Subject: Payzant Drive / Wentworth Road Roundabout Design

Council approve the award of tender WHRMPW24-03 for Construction of the Payzant Drive/Wentworth Road Roundabout to the low compliant bidder, Dexter Construction, for the tendered price of \$4,274,980.00 plus applicable taxes. And, council also approves a construction contingency of 15% (\$641,247) and the cost for overhead utility relocation, for a total construction estimated cost of \$5,116,227 plus applicable taxes.

PAYZANT DRIVE ROUNDABOUT WINDSOR, NOVA SCOTIA

Addendum #2

A
12

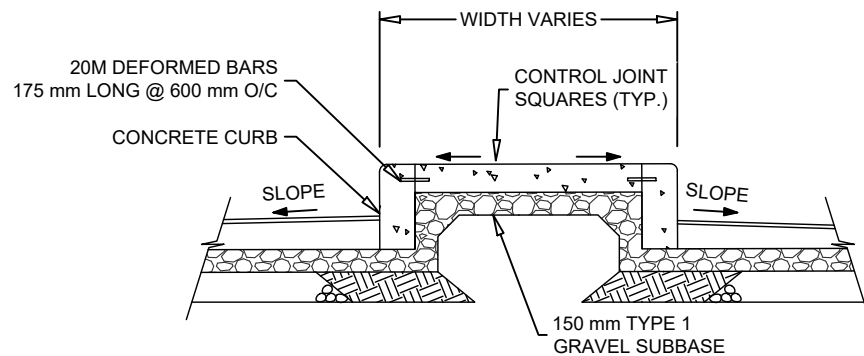
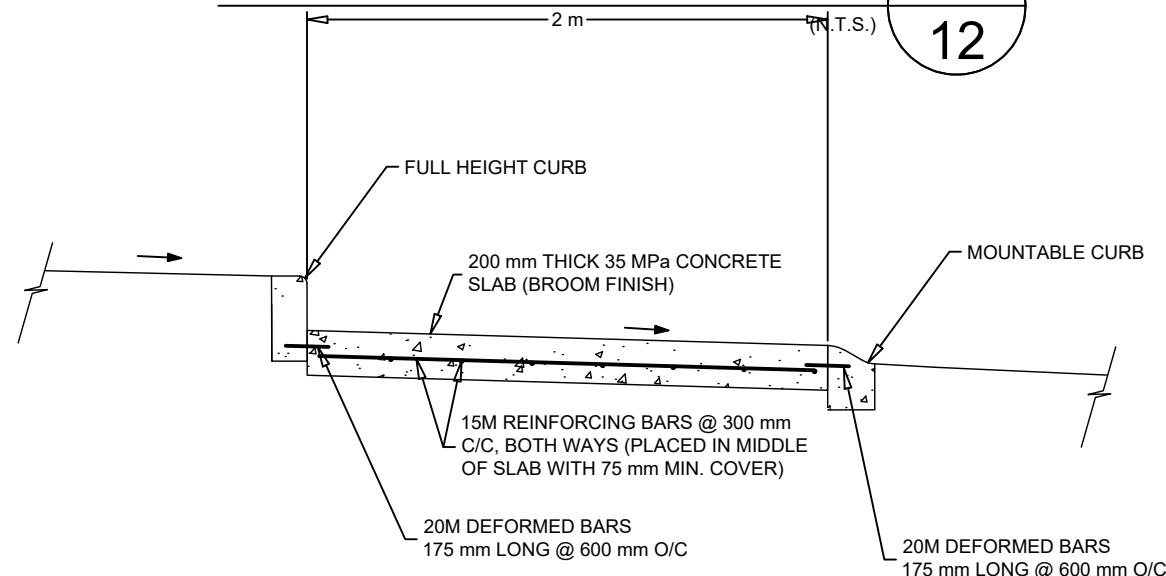
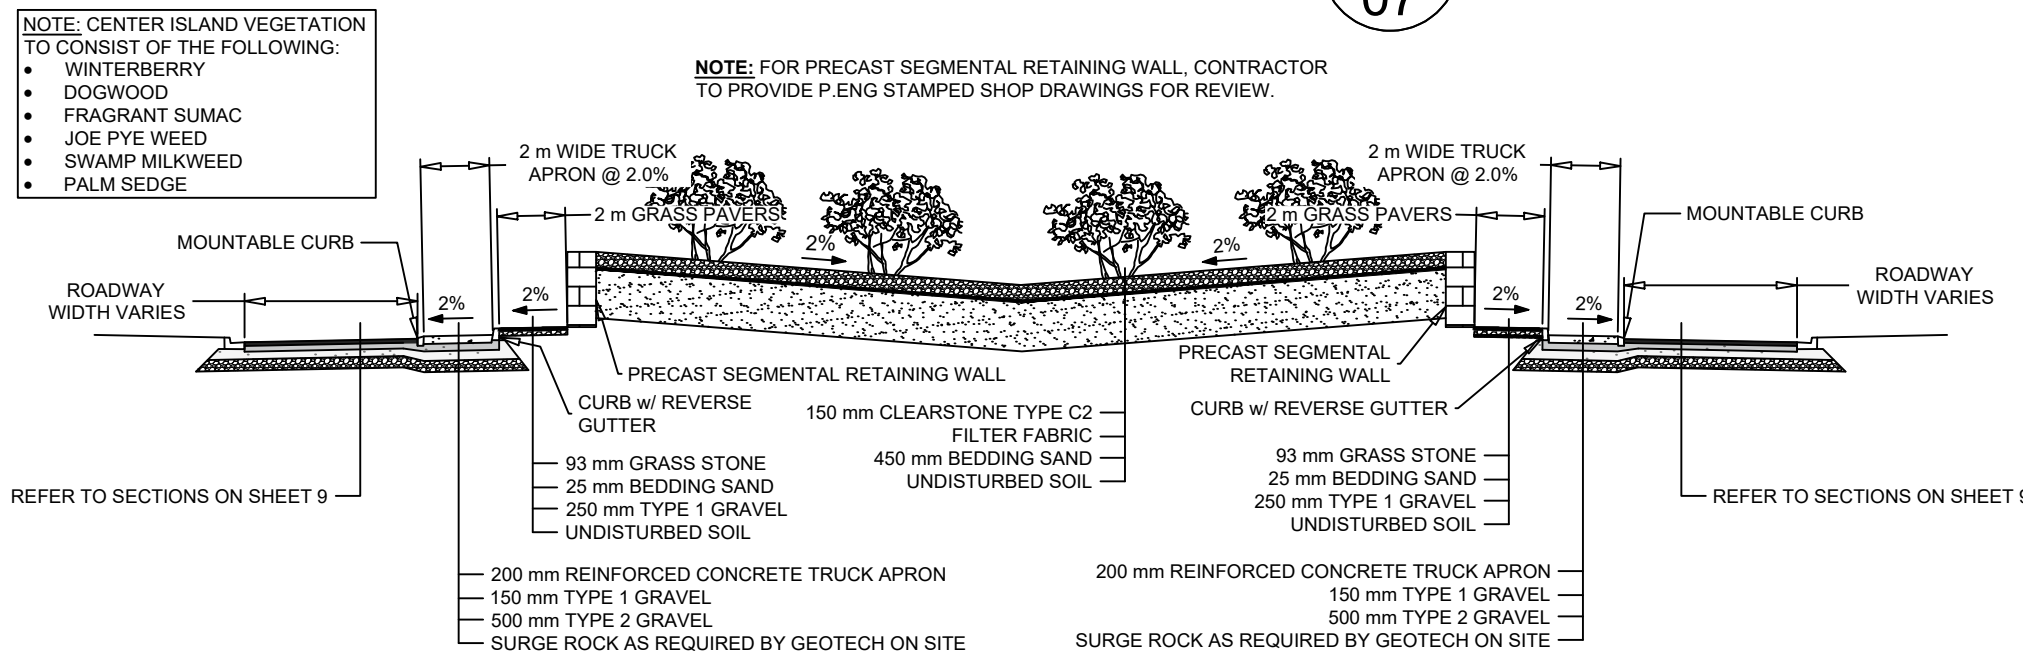
Question 9: After further review of the drawings and discussions at the site meeting, we would ask for some of the curb types to be changed. As discussed at the site meeting, we would ask that the curb around the inner circle of the roundabout be changed to standard NSDPW Type E High Back curb as the truck apron in front of this curb is graded away which makes gutter here redundant. Reverse gutter is also difficult to work with from a grading perspective. We would also ask that the curbed islands be changed to NSDPW Type E High Back Curb. There are no catch basins in the curbed islands and the adjacent asphalt is sloping away from the curb which also

makes gutter here redundant and will likely lead to water being trapped in the gutter. The Curb around the outermost edges of the roundabout island is currently designed as mountable curb with reverse gutter. We would also ask for this to be changed to remove the gutter as the grade on the adjacent asphalt is running away from the curb which makes gutter redundant and will also be much easier to match into with asphalt. We've attached a copy of a standard NSDPW detail that has been being used for this purpose on other roundabouts in the area. Please confirm if this will be acceptable.

Question 10: Detail A on drawing C-D12 has a note pointing to the asphalt in front of the curb that says feathering strip for grading adjustments. please clarify what is meant by this note?

Answer 9: Traffic island curb and gutter may be replaced with curb only. Refer to detail C-12 for roundabout curb detailing

Answer 10: Disregard that note. Note removed in revised detail sheet.

Drawn T.MILLS	Engineer A. SKETCHLEY	Project No. 21-435	Drawing No. C-D14 14 of 14
Scale N.T.S	Filename 21-435_D01_INT-DETAILS.dwg

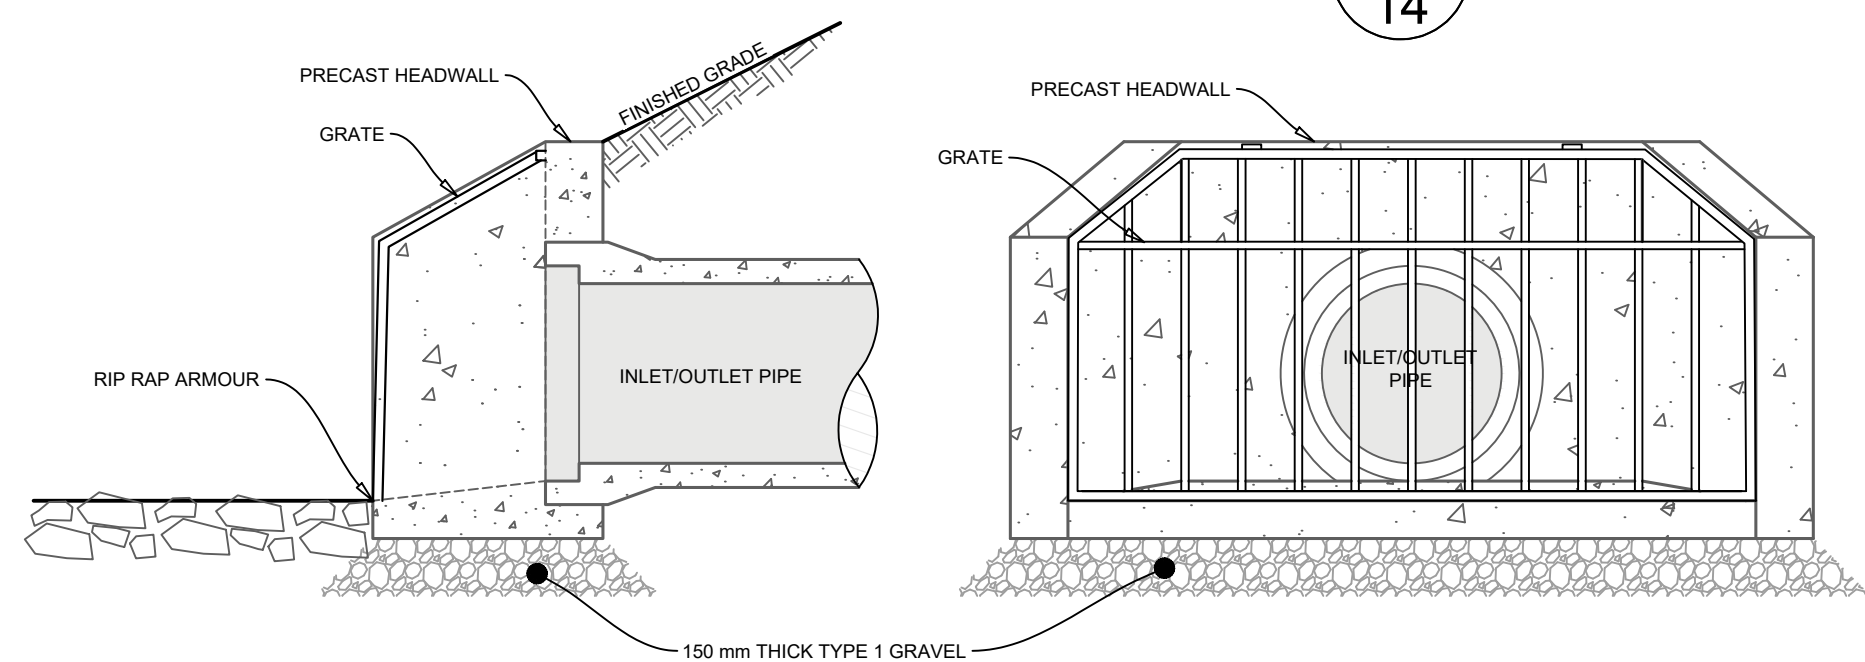
Question 7: There are no details provided for headwalls. Please provide details for headwalls for pipe diameters up to 600mm and for the larger headwall required for the 1200mm pipe extension as well as details for any grates or rails that may be required.

Answer 7: See the updated detail sheet 14.

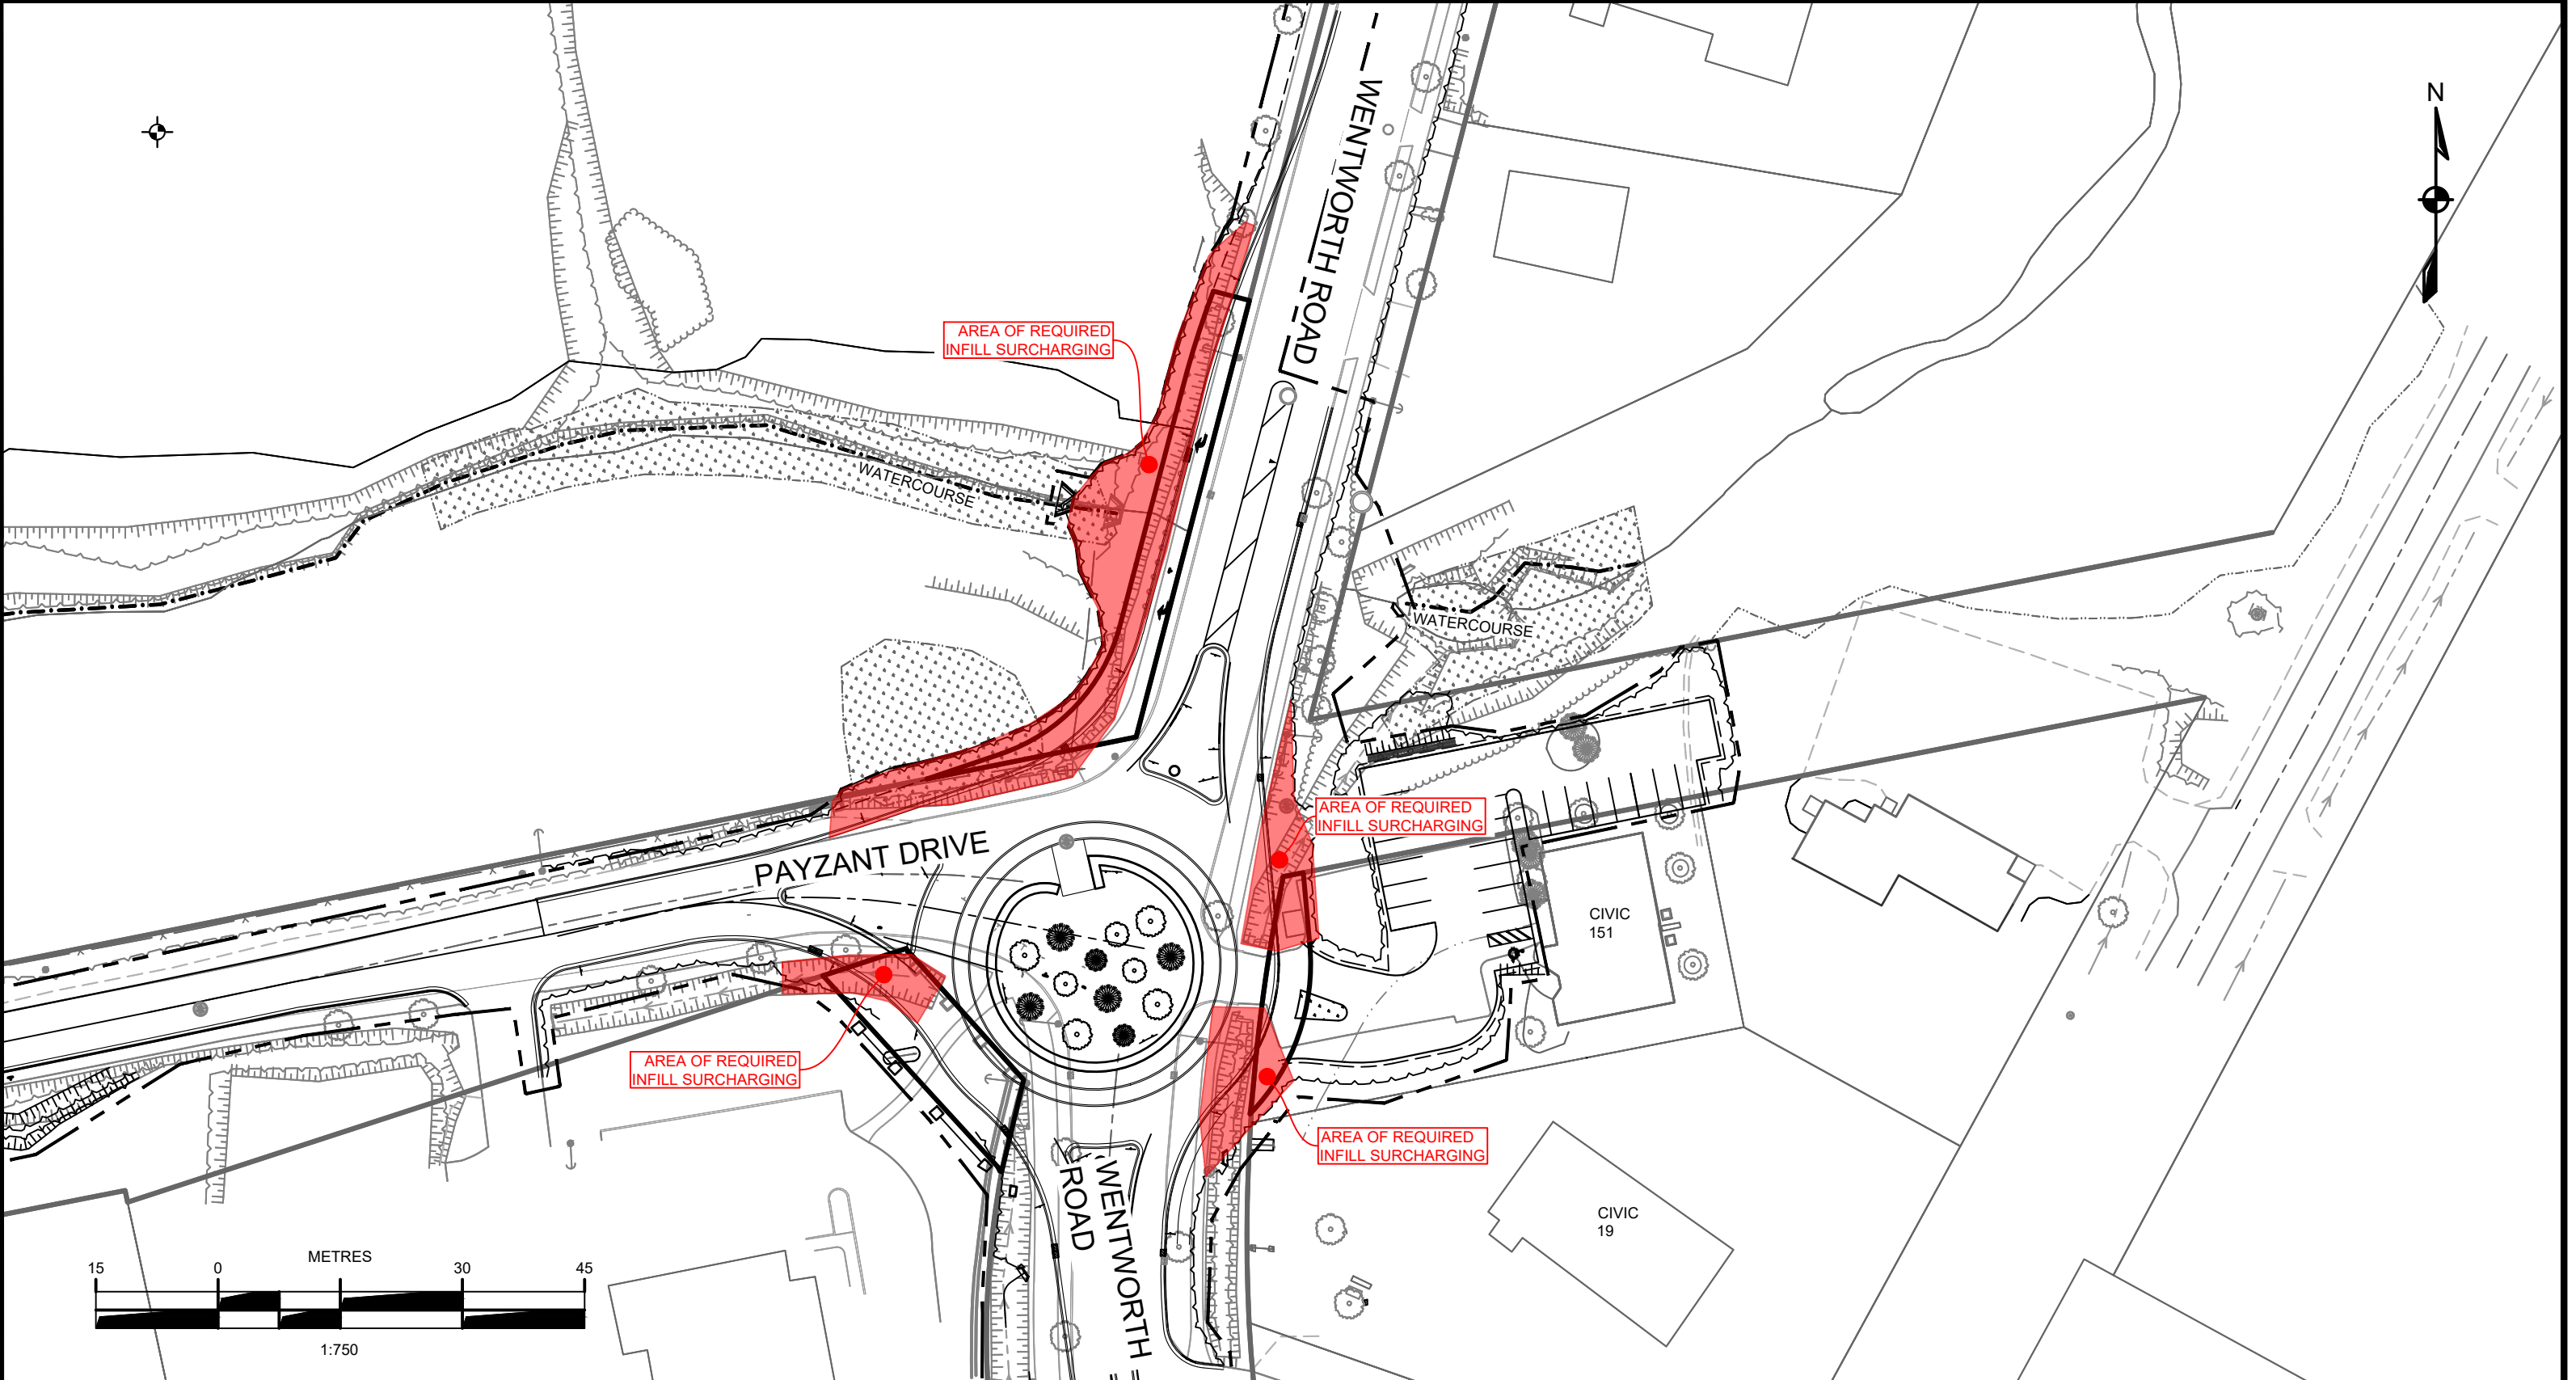
Question 3: There is mention in the Geotechnical report under grade increases/settlement that preload/surcharge may be required for fill areas. As discussed at the site meeting and indicated in the geotechnical report, if this was required it would have had to be completed long before the project was tendered. Can you please confirm this won't be applicable for this project?

Answer 3: See the attached Infill Surcharging sketch and pay item 9.
